## Product Change Notice (PCN)

**PCN Number:** PCN-0370542-01

**CMT-8504-100-SMT-TR**

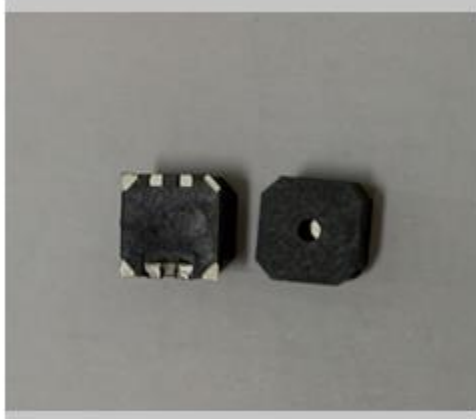
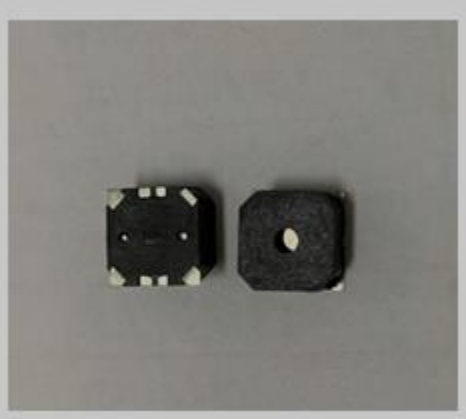
**Improving the structure by changing the bottom to integrated with injection molding, and the connection parts being put inside. The item will now be done by machine to increase the capacity of production.**

**The only change is the injection Molding. This does not change any of the Characteristics of the product.**
